Replacing the center wire in your ATOS

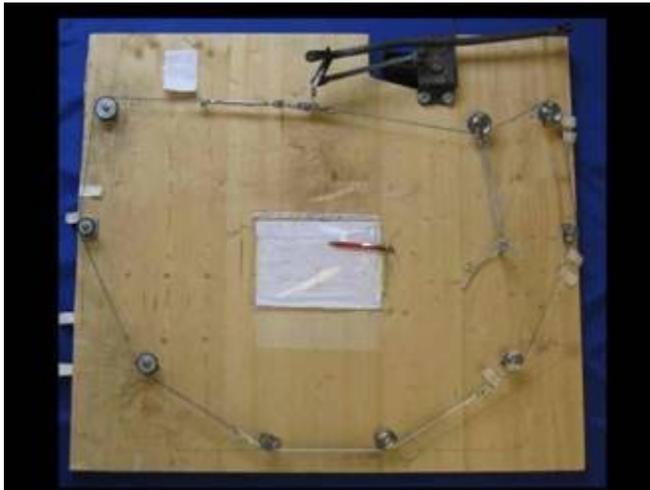
You want to be sure that the control frame is very tight so that it doesn't flop around as you are flying.

You'll want to check your spoilerons to determine when you move the control frame from side to side that the spoilerons rise the same amount of movement to each side of the control frame.
